Access Compliance Report

Public Rights-of-Way

(Curb Ramps)

Intersection ID: 6377	Main Street: KATHERINE_KIKER_RD	Cross Street: KAYCE_LN	Location: NW
ADA ID: 90BB99217FFD	Ramp Type: Perp	Initial Pass/Fail: Fail	Overall Compliance: No
Severity Score: 12.5			
Codes/Mitigation Info/Possible Solution		Field Measurements/Component Compliance

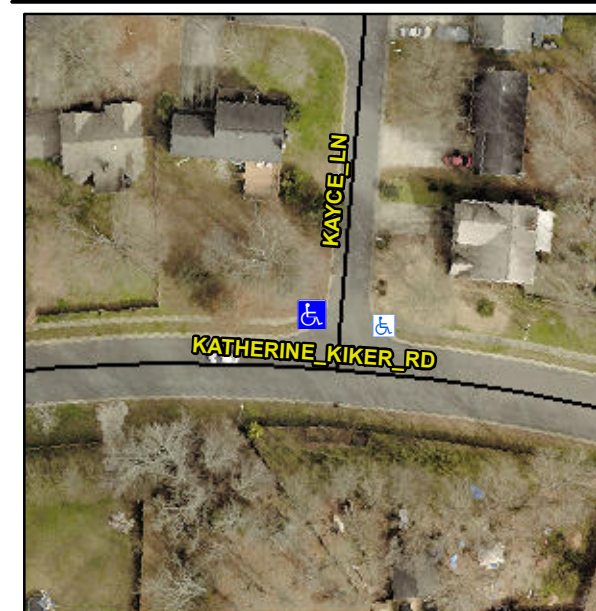
Not Found, R304.5.3

Compliance	Description	Data	Compliance	Description	Data
N/A	Ramp Length (in)	56.5	Yes	Ramp Slope (%)	6.9
Yes	Ramp Width (in)	50.0	No	Ramp XSlope (%)	6.3
N/A	Flare Type LT	N/A	N/A	Flare Type RT	N/A
N/A	Flare Slope LT (%)	N/A	N/A	Flare Slope RT (%)	N/A
N/A	Flare Traversable LT?	N/A	N/A	Flare Traversable RT?	N/A
N/A	Landing Length (in)	N/A	N/A	DWS Provided?	N/A
N/A	Landing Width (in)	N/A	N/A	DWS Contrast?	N/A
N/A	Landing Slope (%)	N/A	N/A	DWS Length (in)	N/A
N/A	Landing X Slope (%)	N/A	N/A	DWS Full Width?	N/A
N/A	Landing Curb? (Y/N)	N/A	N/A	DWS Offset (in)	N/A
N/A	Shared Landing?	N/A			
N/A	Gutter Ponding?	N/A	N/A	Gutter Slope (%)	N/A
N/A	Gutter Lip Ht (in)	N/A	N/A	Gutter X Slope (%)	N/A
N/A	Painted X Walk1?	No	N/A	Painted X Walk2?	N/A
	X Walk 1 Direction	To NE		X Walk 2 Direction	N/A
N/A	X Walk 1 Width (in)	N/A	N/A	X Walk 2 Width (in)	N/A
	X Walk 1 Slope (%)	3.6		X Walk 2 Slope (%)	N/A
	X Walk 1 X Slope (%)	7.2		X Walk 2 X Slope (%)	N/A

Remove & Replace Entire Ramp.
